Subject: SUIT AND HELMET SESSION WITH [redacted]
OF DAVID CLARK, 23 MARCH 1966

RECORD OF SUIT AND HELMET SESSION WITH

[REDACTED] OF DAVID CLARK, MARCH 23, 1966

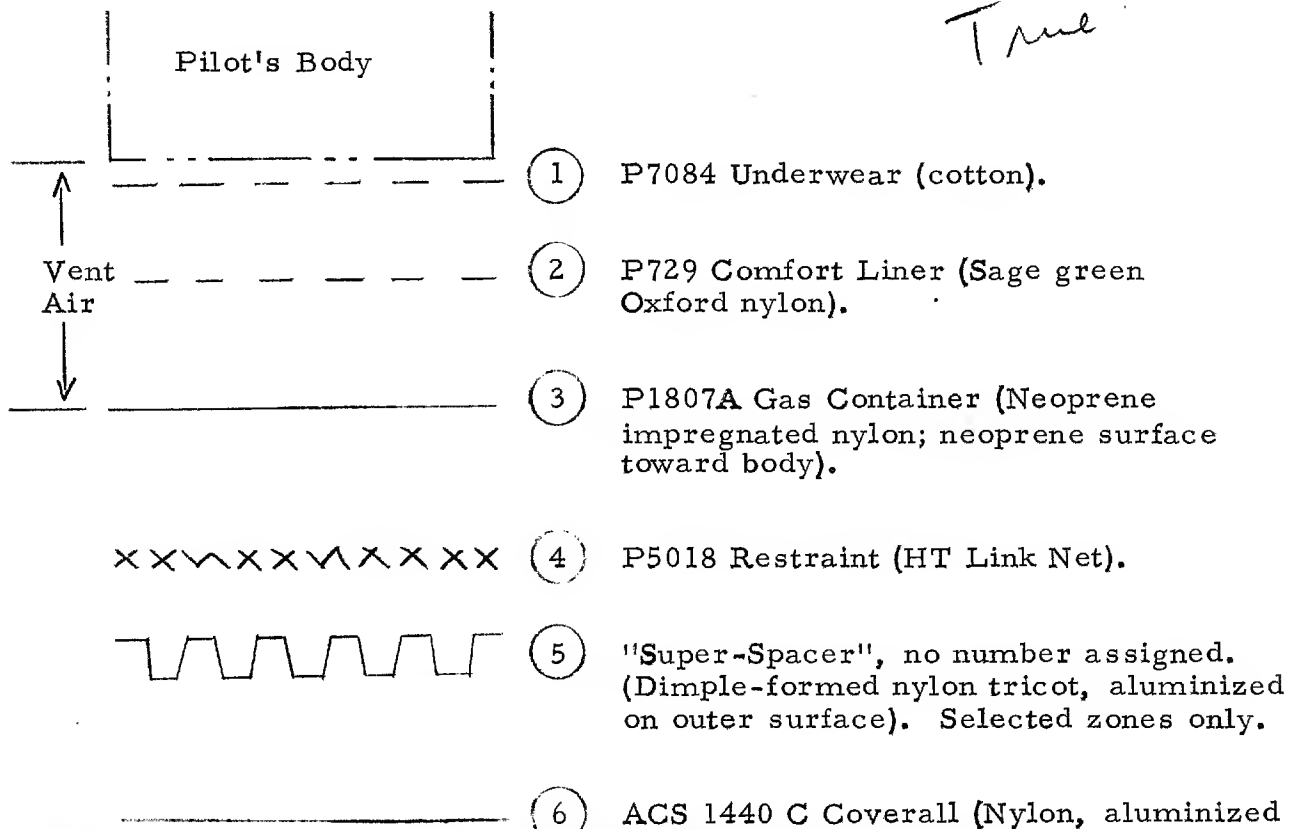
3. Two separate sunshield configurations should be made for test, each with I.R. reflective coating on the outer surface and anti-glare coating on the inner surface.

A. Clear Sunshade - This will be of a material and thickness similar to the existing dark green sunshade, except clear.

B. Sunshade -

This will be like our existing dark green sunshade, except for the coatings as stated. The I.R. coating may turn out to be a gold deposition, but no where near the density of the Gemini gold shield we have been testing.

- Negative*
4. Without being familiar with the mechanics of the Gemini hardware, we stated more or less conversationally that the clear shield should be the one to come down with the first manipulation of the knob, and that it would be satisfactory, and possibly desirable, to have both shields down if the sunshade were needed. These ideas may or may not be significant in terms of the actual hardware. *problem*

4 being procured - I.R.
outside AR inside

No - our effort here

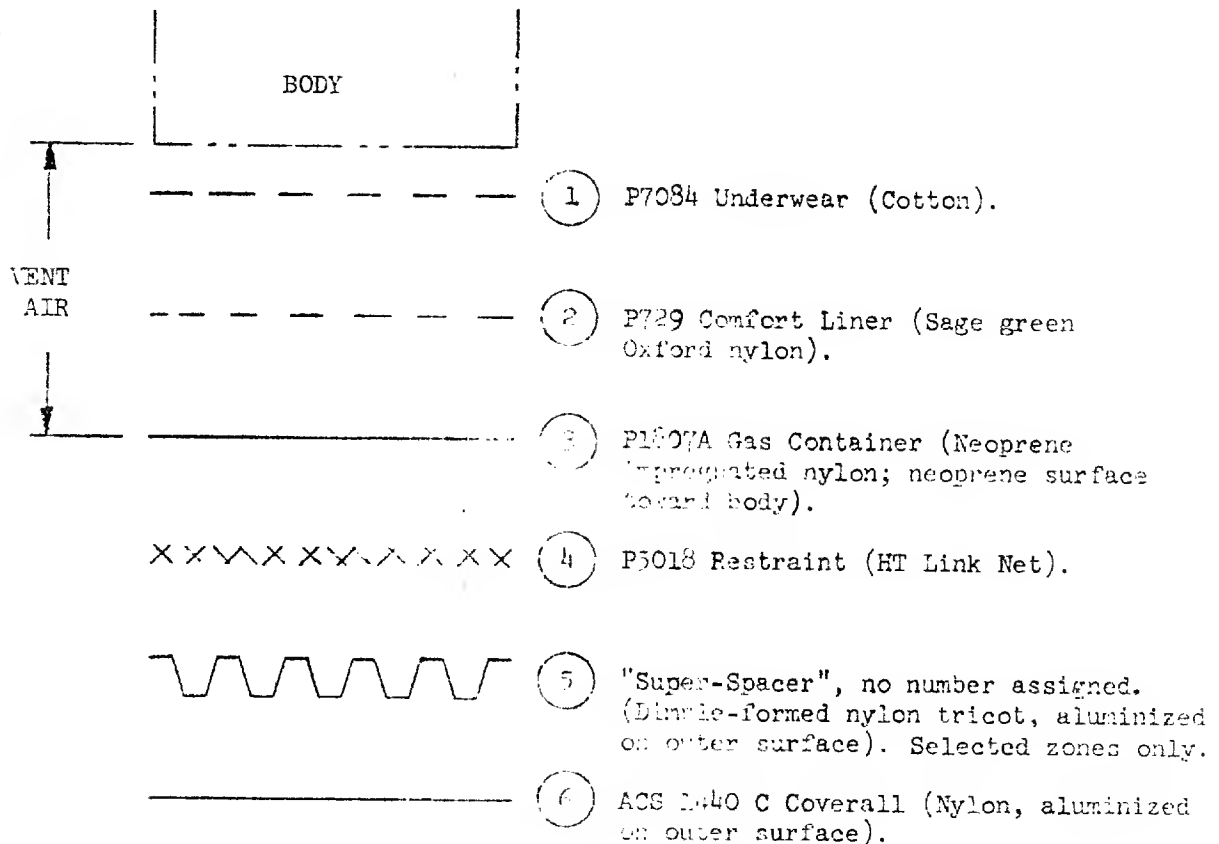
- (1). It was concluded that a single panel I.R. shield with a clear lower section and an upper sunshade section would be unsatisfactory and should not be considered further; the most apparent of several problems is that when flying into the sun, the illuminated face would cause very bad self-reflection in the sunshade portion.
- (2). The hardware problems of mounting and operating multiple auxiliary shields have already been solved on the Gemini helmet, so we felt no compunction about specifying the double shields below. However, having no feel for what we will be getting, we would like to have a sample to examine; Walter will transmit to [] our request to arrange if possible for a two-week loan of a typical helmet.
- (3). Two separate auxiliary shields shall be provided, each with I.R. reflective coating on the outer surface and anti-glare coating on the inner surface.

CLEAR SHIELD - This will be of a material and thickness similar to the existing dark green sunshade, except clear.

SUNSHADE - This will be like our existing dark green sunshade except for the coatings as stated. The I.R. coating may turn out to be a gold deposition, but nowhere near the density of the Gemini gold shield we have been testing.

- (4). Without being familiar with the mechanics of the hardware, we stated more or less conversationally that the clear shield should be the one to come down with the first manipulation of the knob, and that it would be satisfactory (and possibly desirable) to have both shields down if the sunshade were needed. These stipulations may or may not be significant in terms of the actual hardware.
